Application No. FDEC-R4-38

**Partial Revision of the Application for approval to amend the
Implementation Plan for Fukushima Daiichi Nuclear Power Station as
Specified Nuclear Facility**

TEPCO partially revise Application for approval to amend the Implementation Plan for Fukushima Daiichi Nuclear Power Station as Specified Nuclear Facility, which submitted on Dec. 21, 2021 (Application No. FDEC-R3-175) and partially revised on Apr. 28, 2022 (Application No. FDEC-R4-23), as per the attached document.

The following amendments are made to installation of the ALPS treated water dilution/discharge facilities and the related facility, and discharge of ALPS treated water into the sea, according to the Optimization of description.

Fig.4 Conceptual Drawing of Seawater Intake Facilities

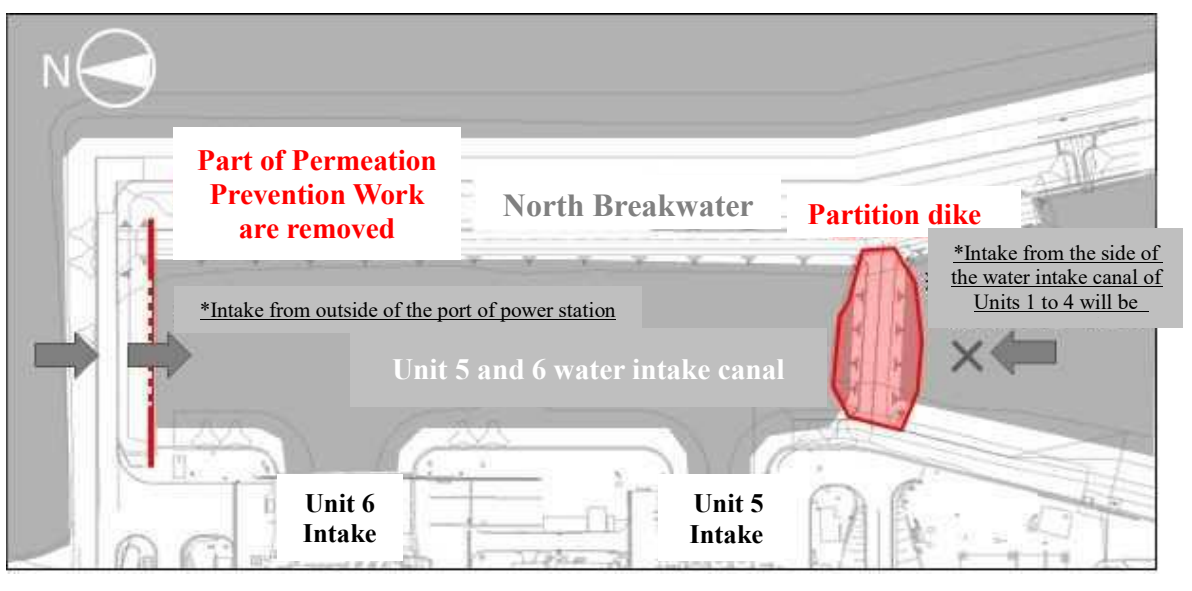
Current	Revised	Reason for Revision																																																																																																																																																		
		<p>Addition of installation of partitioning dikes for discharge of ALPS treated water into the sea Optimization of the description (reflection of drawings in line with actual conditions of the site)</p>																																																																																																																																																		
<p>Fig. 2 Plans for monitoring seawater inside and outside port and groundwater (sampling points) (Omission)</p>	<p>Fig. 2 Plans for monitoring seawater inside and outside port and groundwater (sampling points) (Omission)</p>

Current	Revised	Reason for Revision
	 <p>The diagram shows a plan view of the seawater intake facilities. A North Breakwater is located at the top. A Partition dike is shown as a red-shaded area. A Unit 5 and 6 water intake canal runs horizontally. Unit 6 Intake and Unit 5 Intake are labeled at the bottom. A red vertical line indicates where permeation prevention work has been removed. Arrows show water intake from the outside of the port and from the side of the canal for Units 1 to 4. A north arrow is in the top left corner.</p> <p>Part of Permeation Prevention Work are removed</p> <p>North Breakwater</p> <p>Partition dike</p> <p>*Intake from outside of the port of power station</p> <p>Unit 5 and 6 water intake canal</p> <p>*Intake from the side of the water intake canal of Units 1 to 4 will be</p> <p>Unit 6 Intake</p> <p>Unit 5 Intake</p>
